Detailed Site Plan Departure of Parking and Loading Standards The Cassidy

DSP-21045
DPLS-22002

SUBJECT: Detailed Site Plan DSP-21045
 Departure of Parking and Loading Standards DPLS-22022
 Type II Tree Conservation Plan TCPH-077-04-03
 The Cassidy

Figure 1: Site Plan

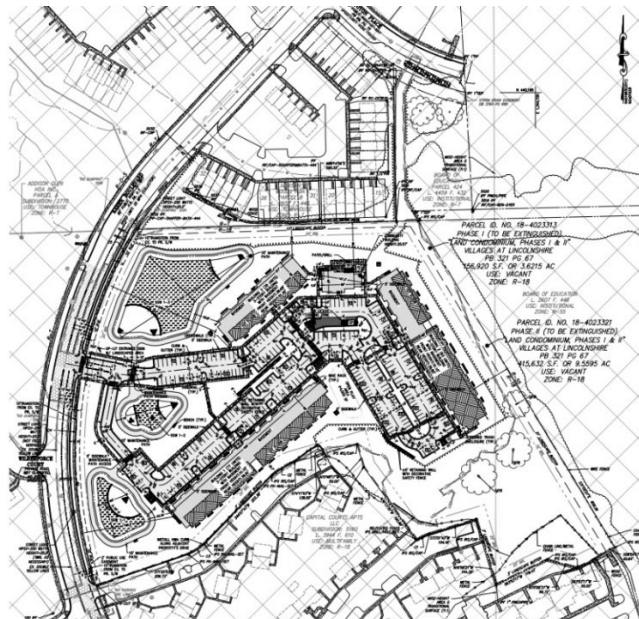
6. **Design Features:** The proposed application is for development of 175 multifamily units within 3 buildings. Each building will be 4 stories and approximately 51 feet tall at its highest elevation. The site will be accessed from a single entrance along Karen Boulevard. Building 1 will contain a total of 77 dwelling units, Building 2 will contain a total of 63 dwelling units, and Building 3 will contain a total of 35 dwelling units. The clubhouse will be 3,596 square feet and located within Building 3. A total of 263 surface parking spaces are provided and the site will have 1 loading space. A companion Departure from Parking and Loading Standards (DPLS-22002) has been filed in conjunction with this DSP to allow for the reduction in 168 parking spaces. SWM facilities will be provided on-site near the entrance and adjacent to Karen Boulevard.

1. Prior to signature approval, the detailed site plan (DSP) shall be revised to replace the plat reference for the subject property on all sheets of the DSP listed as Plat Book 231 plat no. 67 with Plat Book PM 220 plat no. 93.
